RS-14-037

Braidwood Station, Units 1 and 2
Facility Operating License Nos. NPF-72 and NPF-77
NRC Docket Nos. STN 50-456 and STN 50-457

Subject: Response to Request for Additional Information Regarding Relief Request I3R-11 Associated with the Repair/Replacement of Control Rod Drive Mechanism (CRDM) Canopy Seal Welds

Attachment 1: Response to Request for Additional Information Regarding Relief Request I3R-11 Associated with the Repair/Replacement of Control Rod Drive Mechanism (CRDM) Canopy Seal Welds

Fig. 1 Structure of CRDM Housing

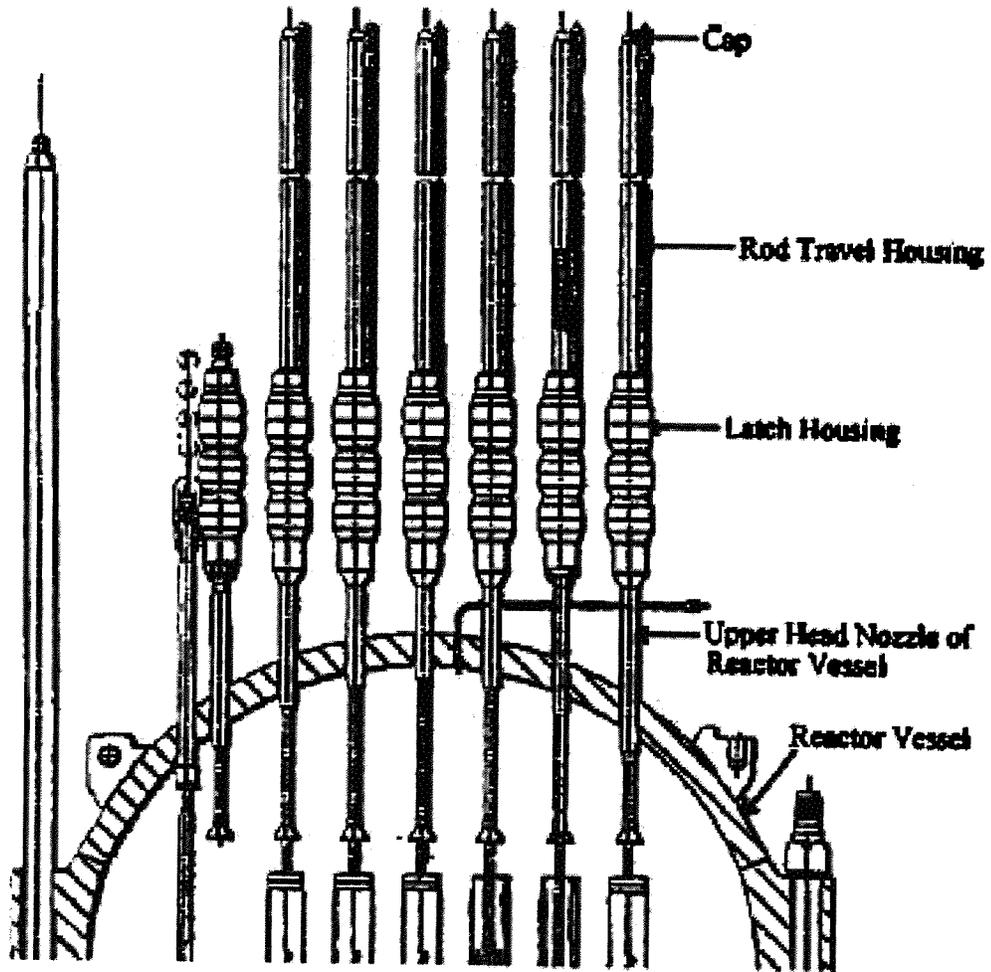
1. Provide drawings and sketches to show/identify the following items:

- (1) Configuration of the canopy seal (how the canopy seal is assembled) and its location with respect to the control rod drive mechanism (CRDM) housing. Identify the diameter of the canopy seal.**

Components associated with the canopy seal welds were assembled using threaded connections, were torqued and seal welded using consumable inserts. The general configuration of the canopy seal welds along with their general location on the control rod drive mechanism assembly are provided in Figures 1 and 2. The approximate diameter of the canopy seal welds ranges from 3.75" (for the upper canopy seal weld) to 6.45" (for the lower canopy seal weld).
